Technical Service Bulletin

Castle Nut Upgrade (Beginning Feb. 2009)

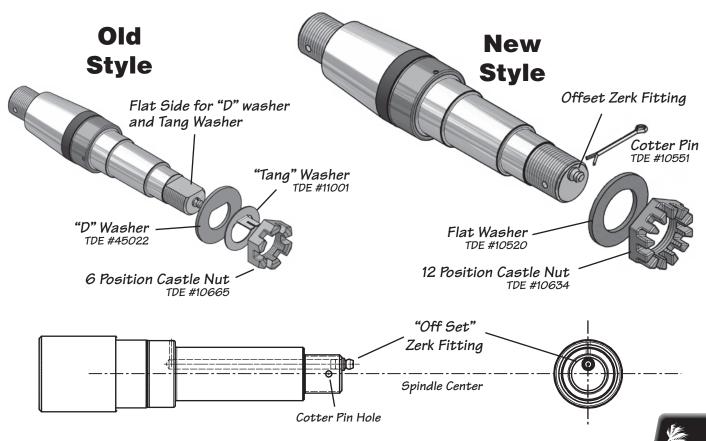
The new 12 position castle nut allows a finer bearing adjustment by having twice the number of positions compared to the older 6 position castle nut. 12 slots make it easier and faster to find the correct position for proper end play. Also changed is the return to the standard flat washer and cotter pin. Both items are easier for consumers to find through conventional retail outlets than the "D" washer and "tang" washers used in the 6 position version. The offset Super Lube zerk is easily accessible when the Super Lube rubber plug is removed from the cap.
